**FPL Energy**  
**Seabrook Station**

Seabrook Station  
Facility Operating License NPF-86  
Response to Request for Additional Information Regarding  
Completion of License Condition 2.K

Enclosure to Letter SBK-L-06081

Response to Request for Additional Information  
Concerning Facility Operation License NPF-86  
Completion of License Condition 2.K

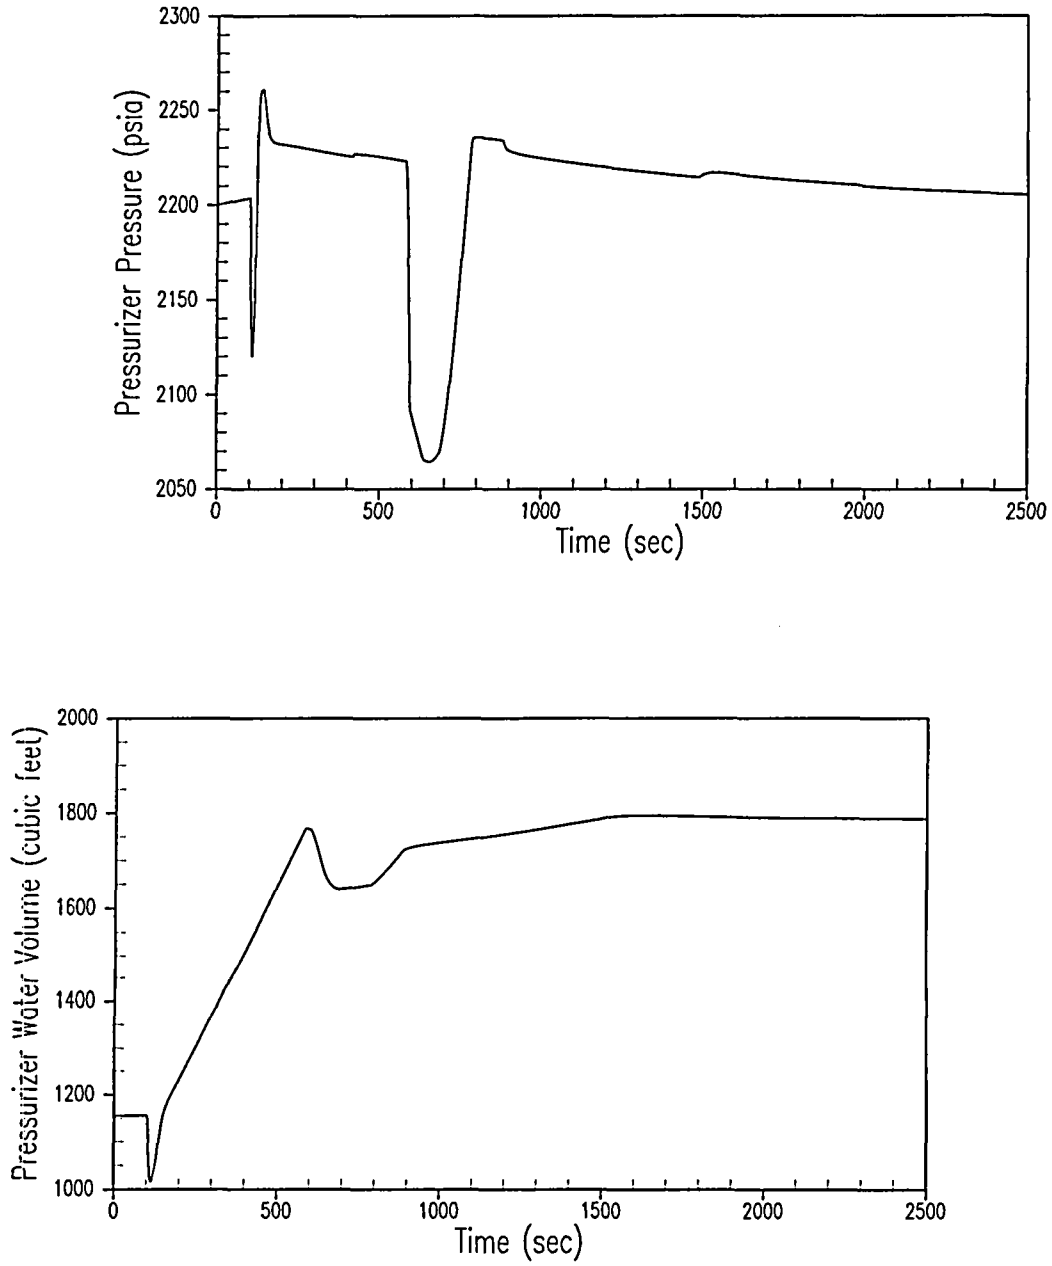
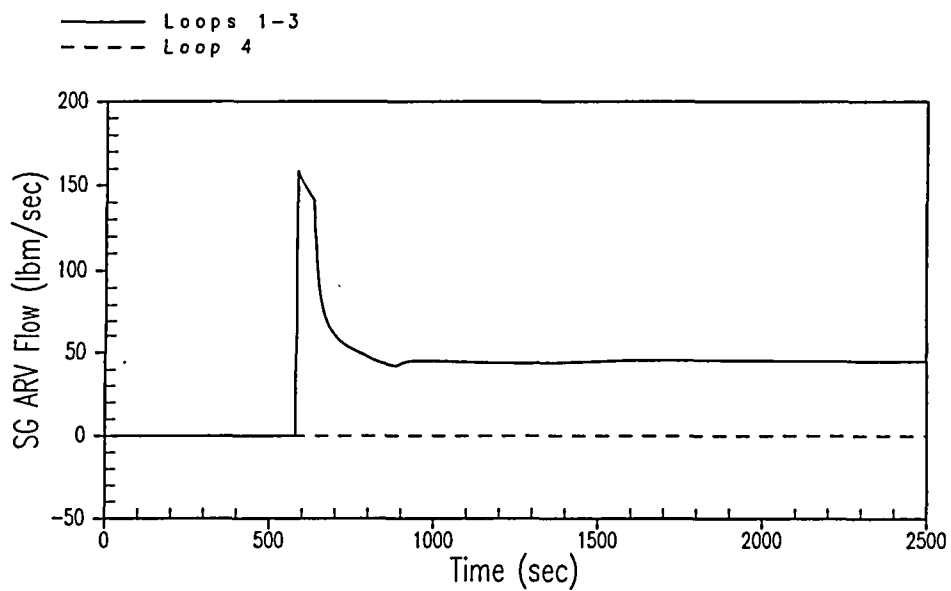
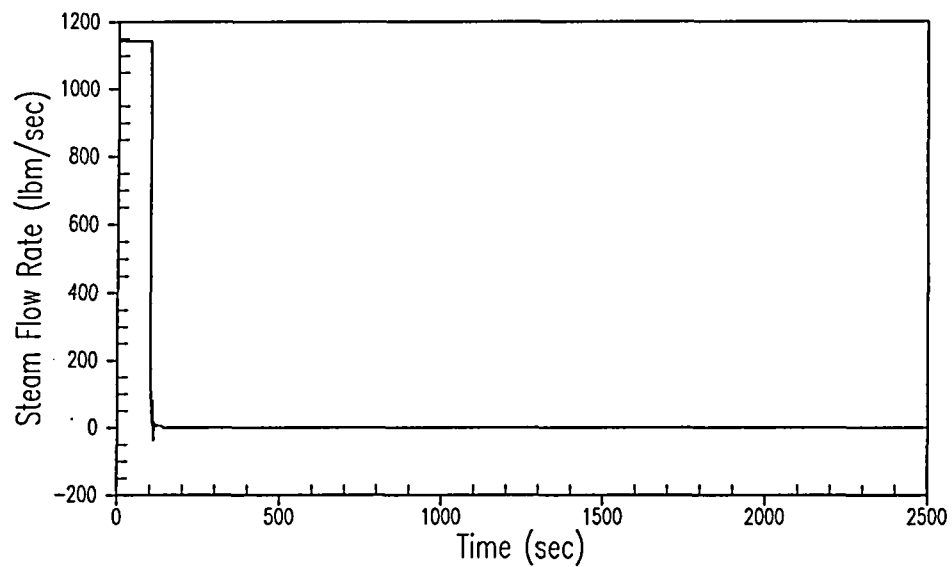
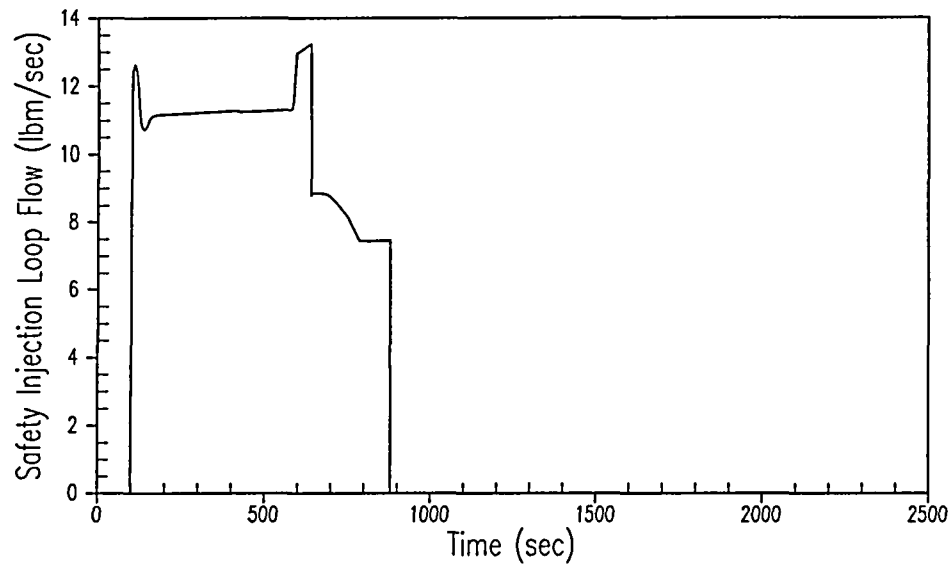
The Seabrook final safety analysis report (FSAR) Section 10.2.3.4 [sic: 10.3.2.4] lists the atmospheric relief valves (ARVs) stroke time to be less than, or equal to, 70 seconds, which appears to be different than the stroke time modeled in the analysis provided in the November 7, 2005, letter. Please clarify this discrepancy or provide an inadvertent emergency core cooling system actuation analysis that takes into account the value listed in the Seabrook FSAR for ARV stroke time.

For the conservative analysis provided in FPL Energy Seabrook, LLC letter (SBK-L-05226) dated November 7, 2005, it was not necessary to explicitly model the atmospheric steam dump valve stroke time due to the relative insensitivity of the results to atmospheric steam dump valve stroke time. The cooling capability of the atmospheric steam dump valves is such that the Reactor Coolant System inventory rapidly cools to provide a significant volume reduction. When the atmospheric steam dump valves are opened anytime prior to a time when the pressurizer is near full capacity, several minutes into the event, the Reactor Coolant System inventory volume reduction is sufficient to prevent pressurizer overfill as described in the analysis. In addition to crediting only three of the available four atmospheric steam dump valves the analysis also conservatively assumes only 70% of the atmospheric steam dump valve flow capacity is available. An additional analysis has been performed at this time to confirm the relative insensitivity of the analysis results to atmospheric steam dump valve actuation or stroke time. This confirmatory analysis was performed crediting full atmospheric steam dump valve capacity as provided in Section 10.3.2.4 of the Seabrook Station UFSAR and delaying the opening of the atmospheric steam dump valves. The results of this confirmatory analysis, summarized below, demonstrates that even if the three of the four atmospheric steam dump valves are not opened until 8 minutes into the event, stopping the charging pumps at 9 and 13 minutes still prevents the pressurizer from going water-solid and confirms the overall conservative bounding nature of the analysis previously provided.

The confirmatory analysis was modeled consistent with the analysis provided in FPL Energy Seabrook letter SBK-L-05226 with the following assumptions:

1. Operator action is taken to ensure three of four atmospheric steam dump valves are full open at or before 8 minutes (corresponding with the computer run time of 580 seconds) after event initiation while maintaining 557°F indicated  $T_{avg}$  for the remainder of the event.

2. The atmospheric steam dump valve flow area is defined in the Seabrook Station UFSAR Section 10.3.2.4.

Figures 1 through 4 below provide the results of the confirmatory analysis.
